MDDP & DBPS AMENDMENT

BENT GRASS DEVELOPMENT

El Paso County, Colorado

DATE:
March 2020
Revised: July 2020
Revised: October 2020
Revised: January 2021

Figure 5-3
Sub-Regional Detention Alternative
Falcon DBPS
El Paso County, CO

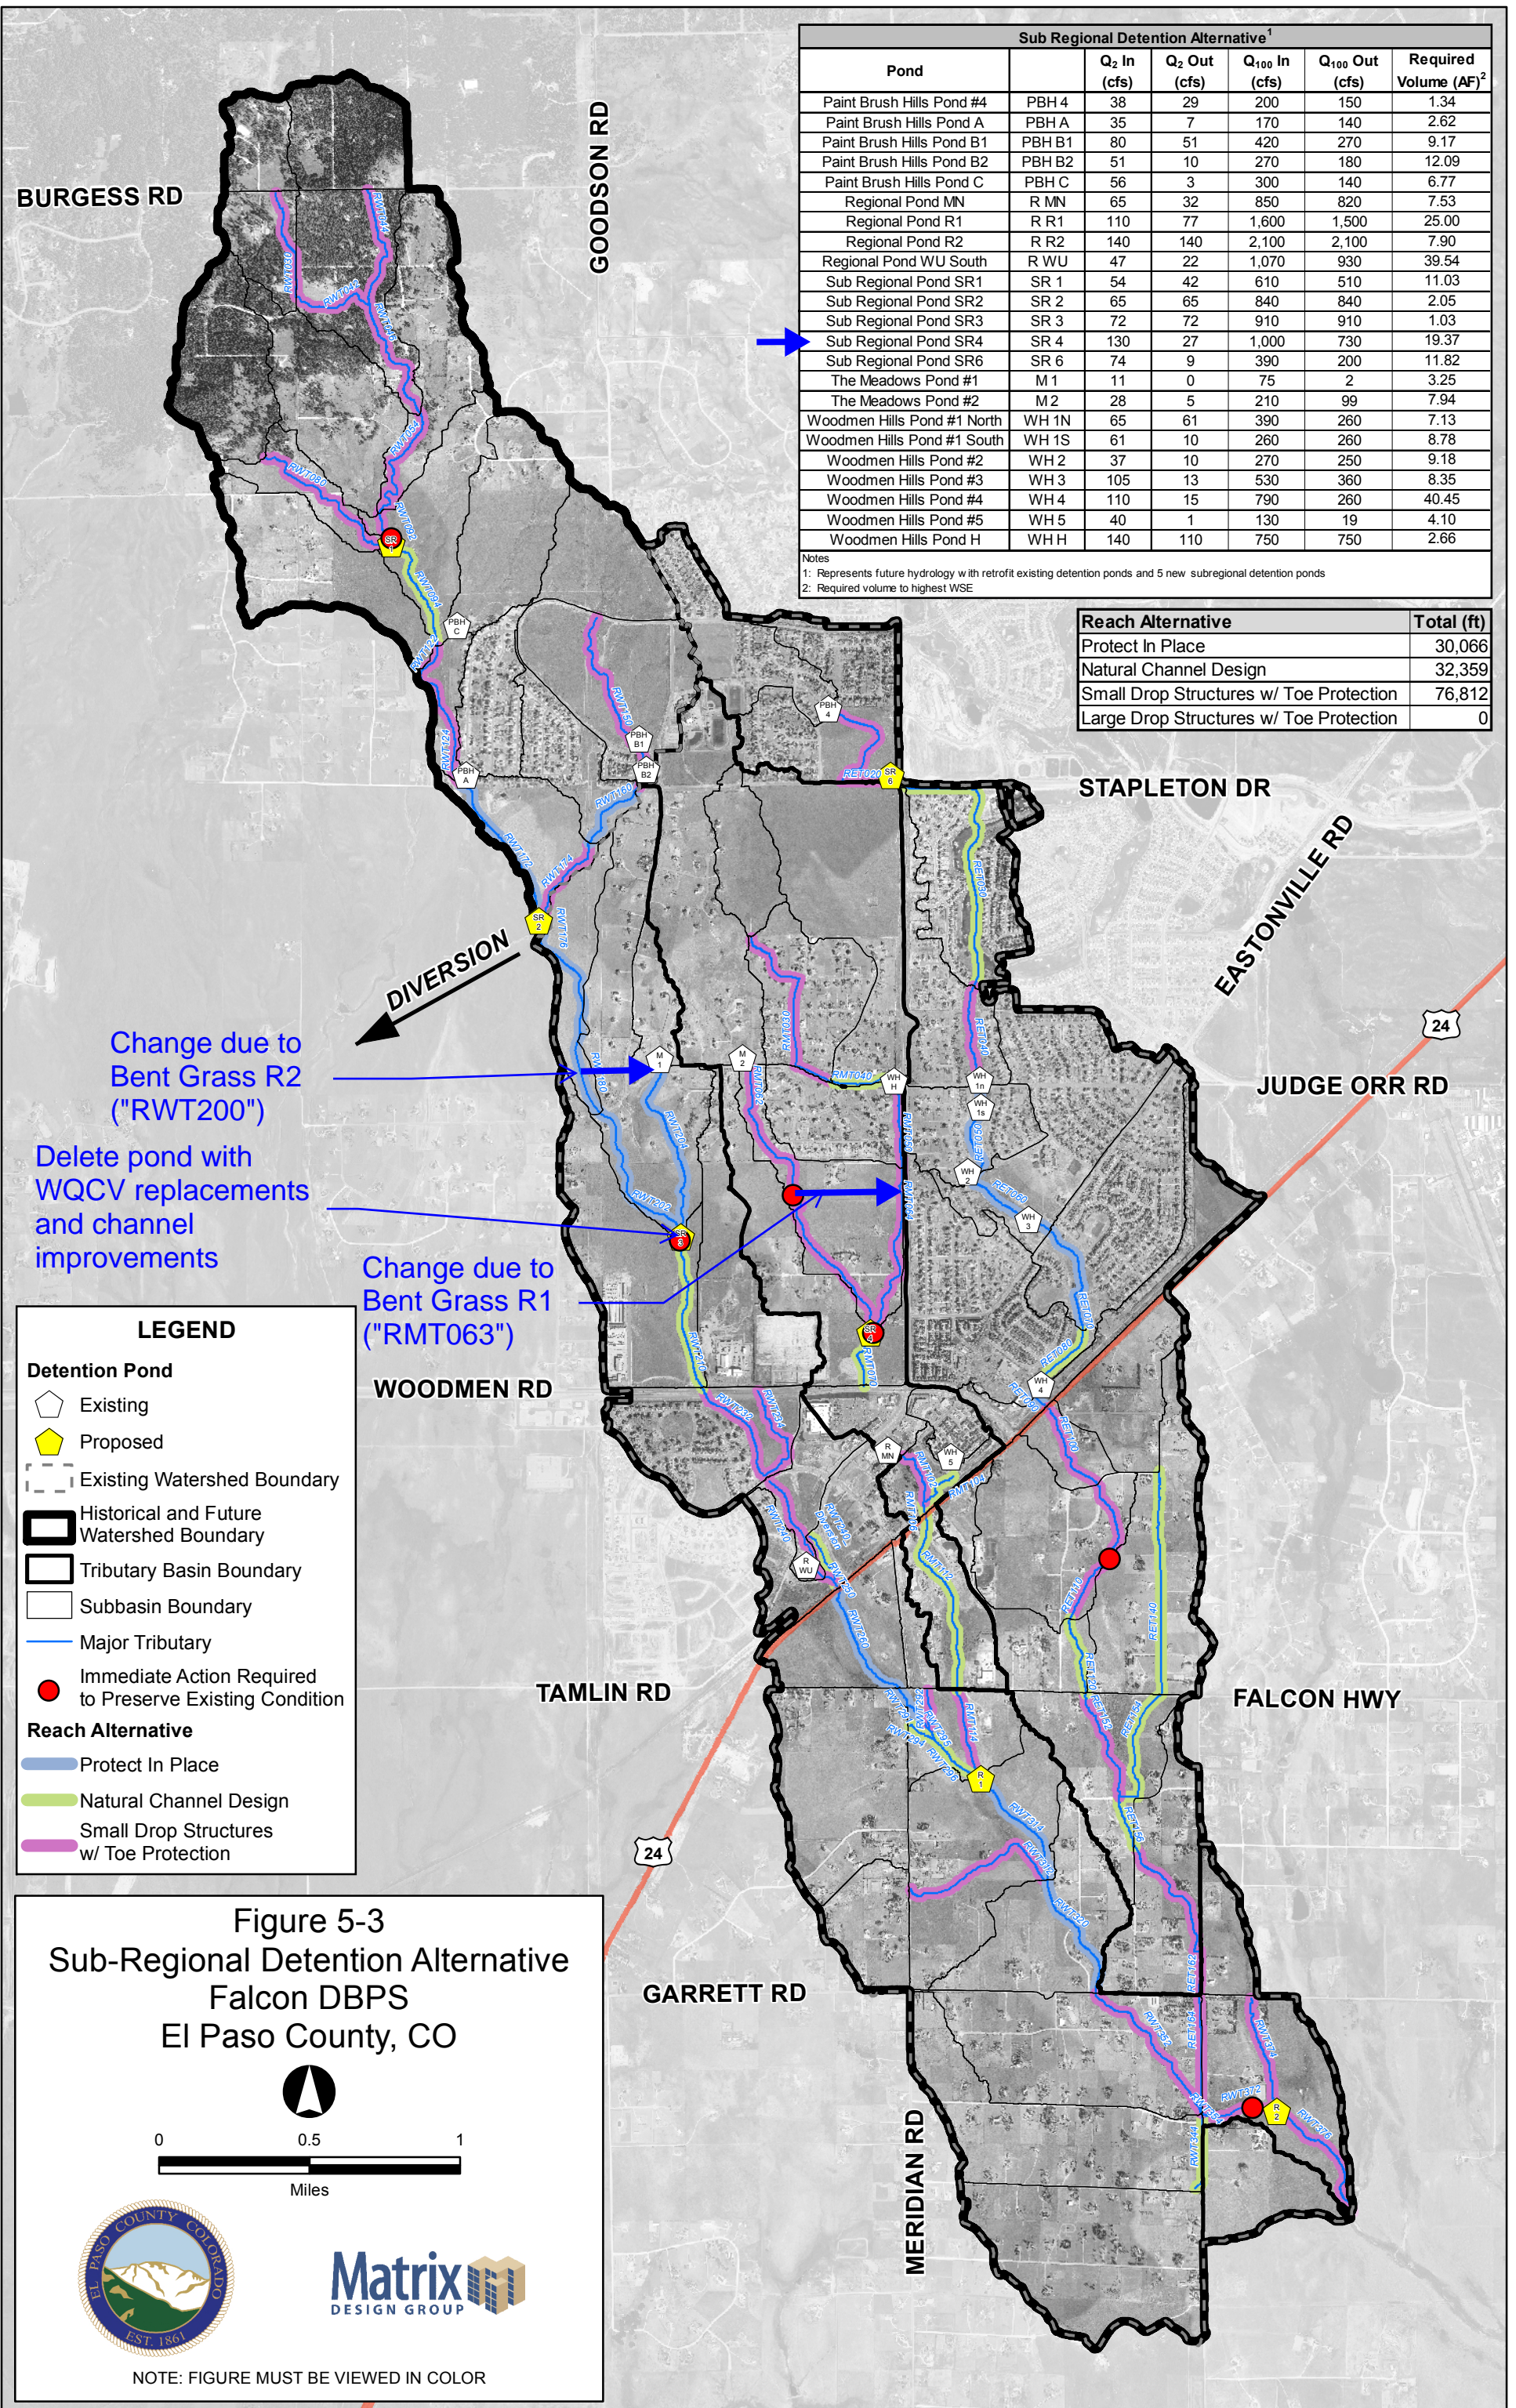
Replace Figure 3-13 (with prev. redlines) and add 3-12 if desired

Figure 3-1
Routing Schematic
Falcon DBPS
El Paso County, CO

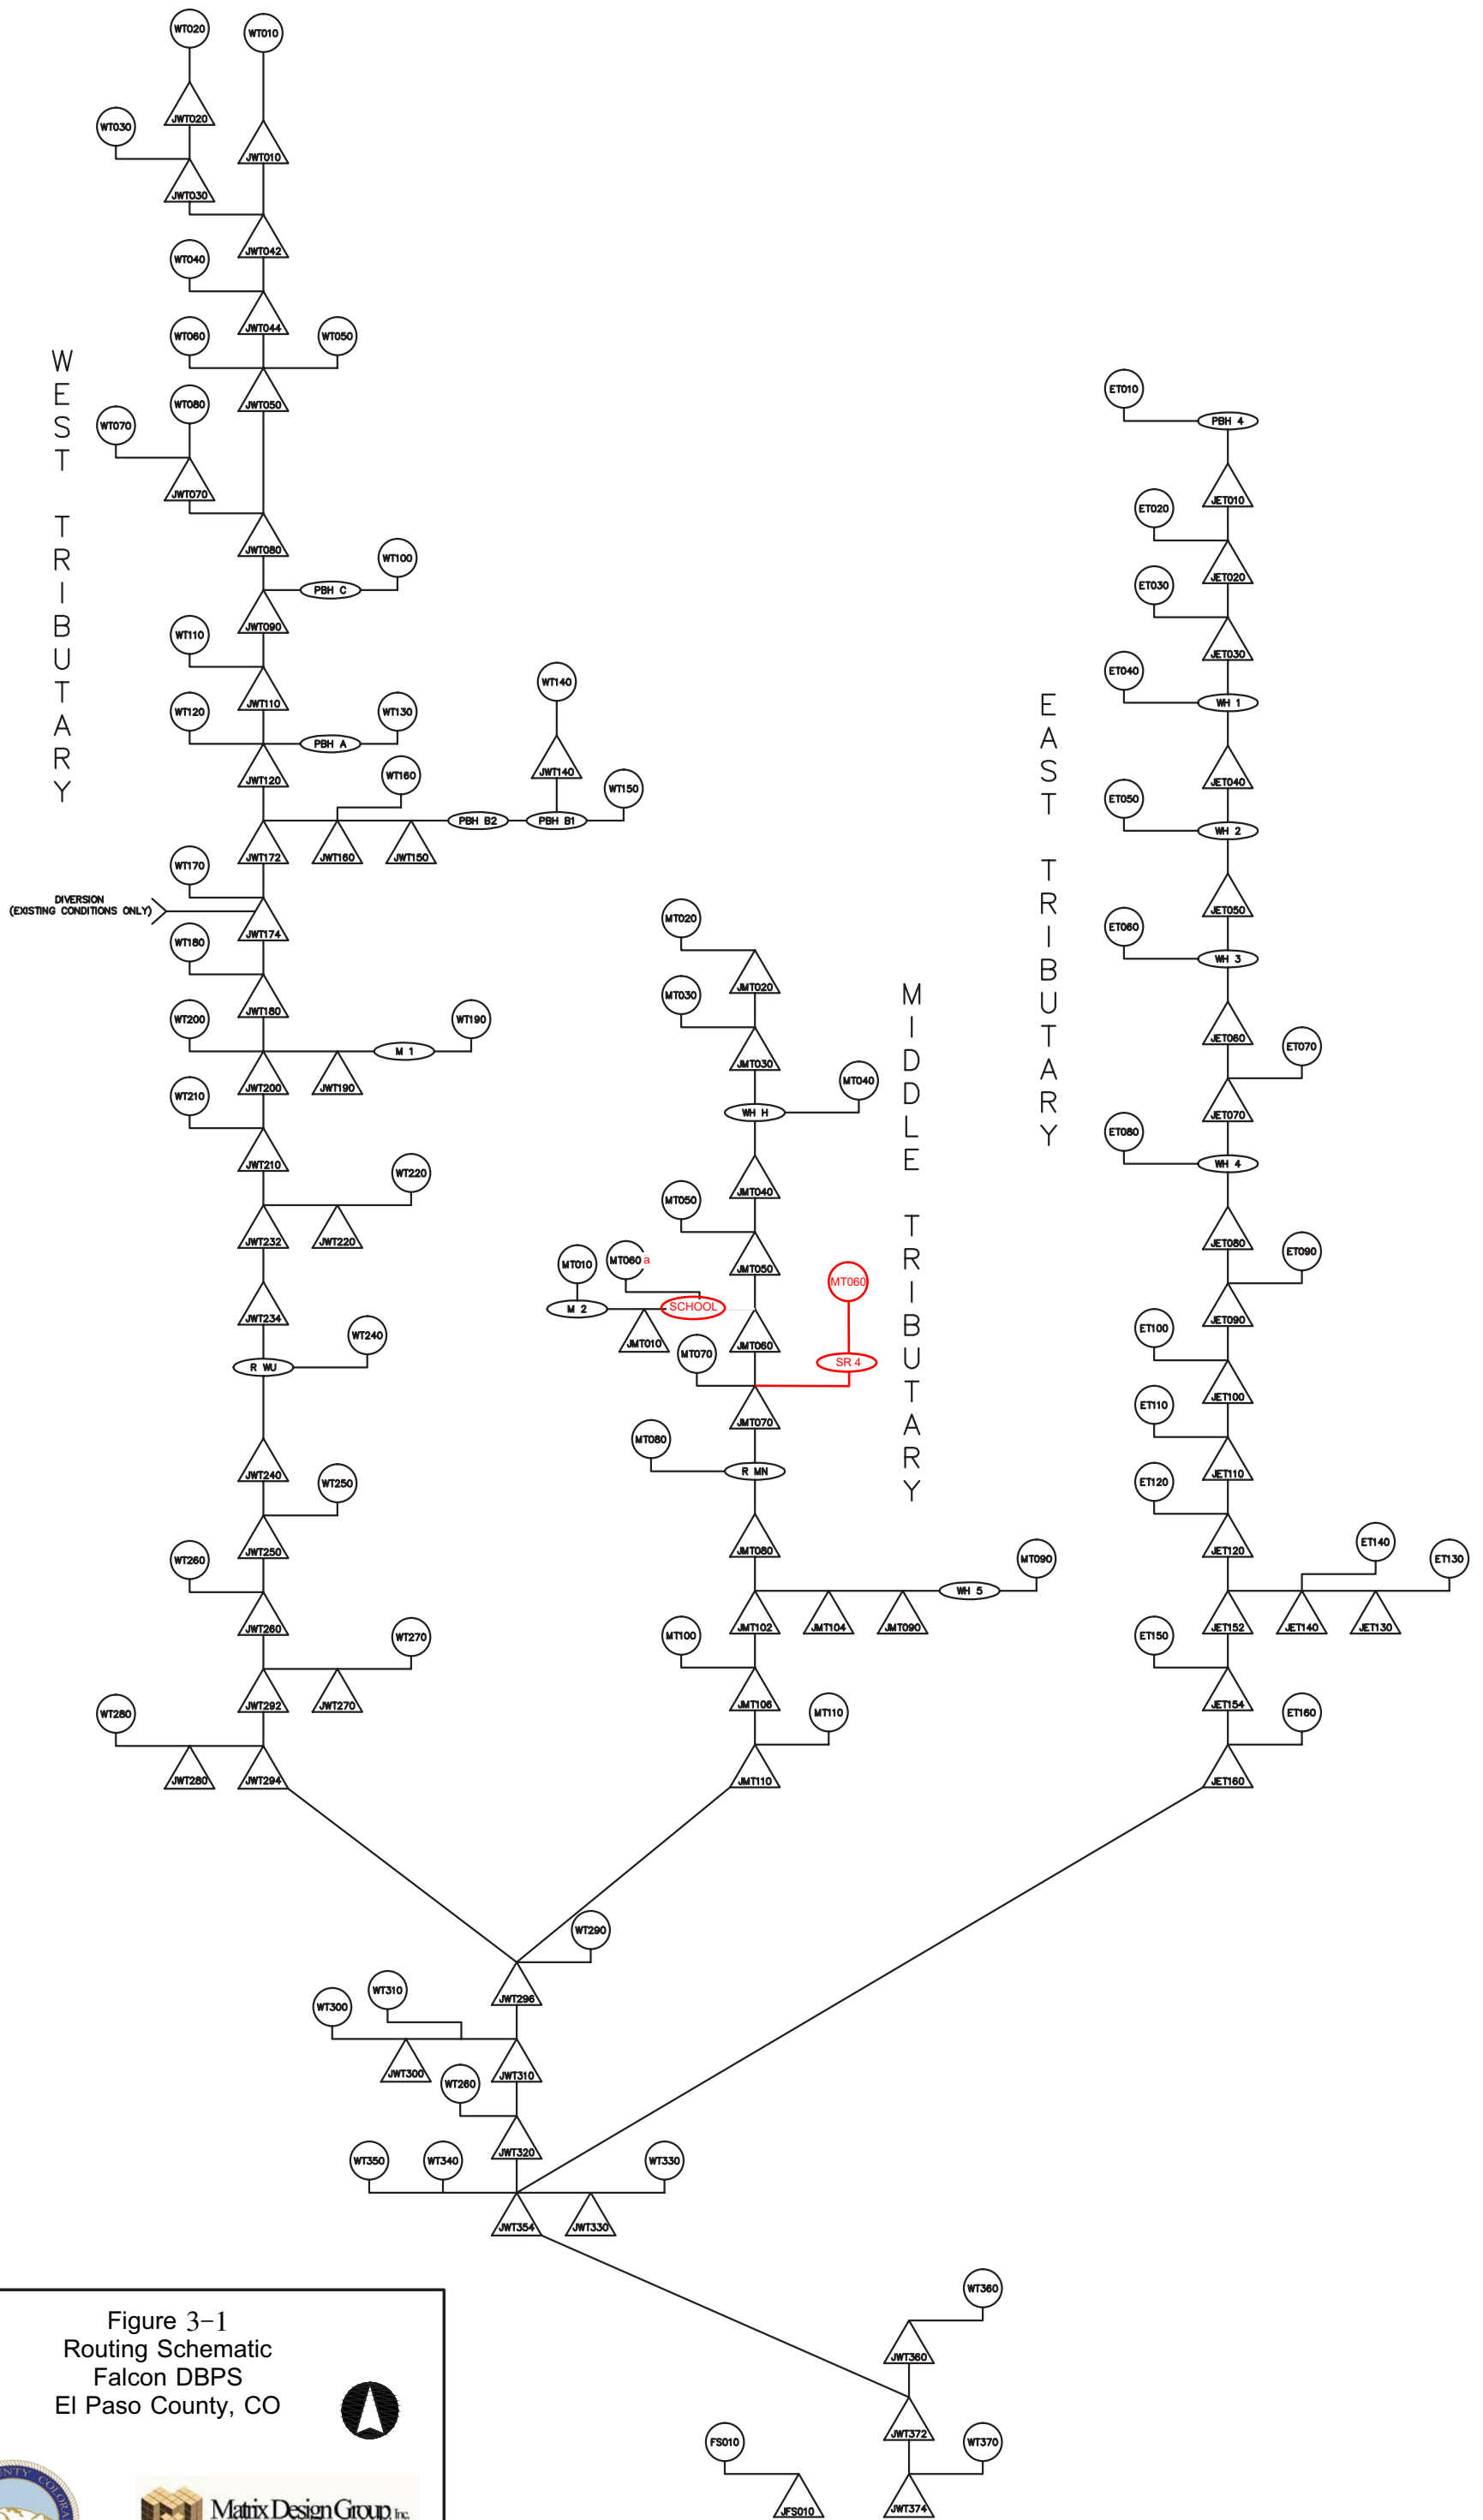
Add label - Future 100-year storm

Add label - Future 5-year storm

Add label - Future 2-year storm

SUB-REGIONAL POND #1 (SR4)

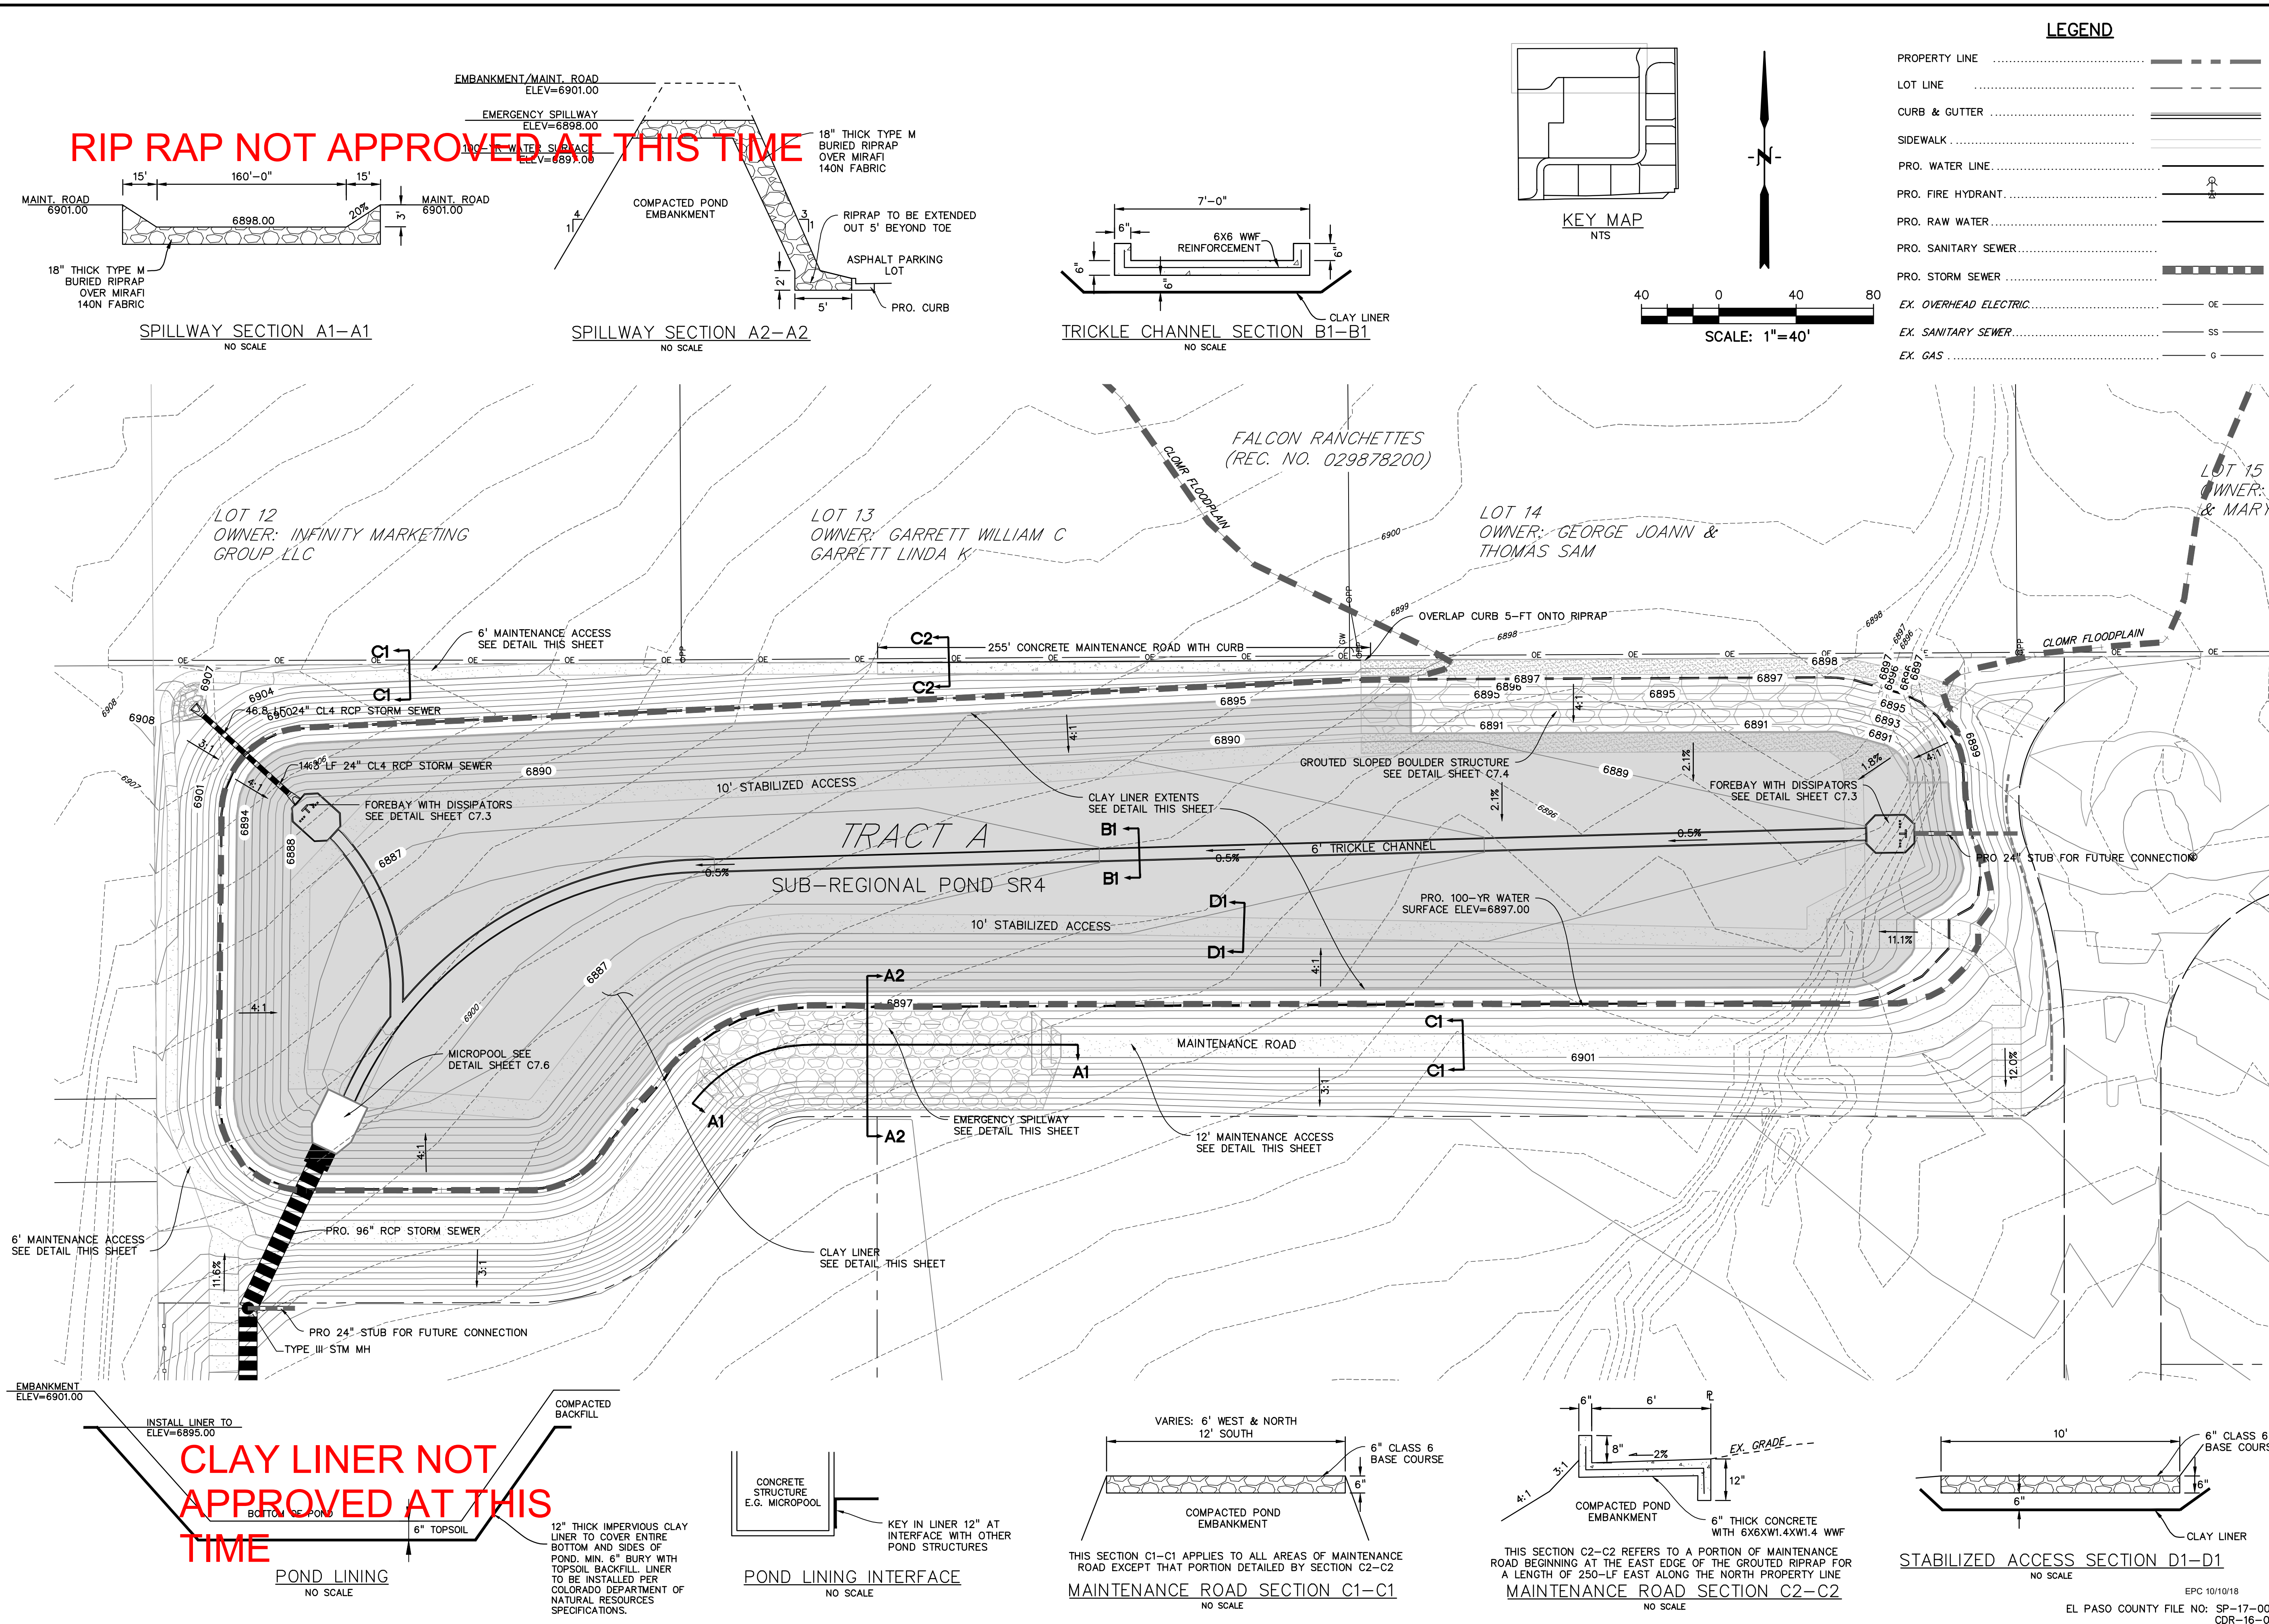
CLAY LINER NOT APPROVED AT THIS TIME
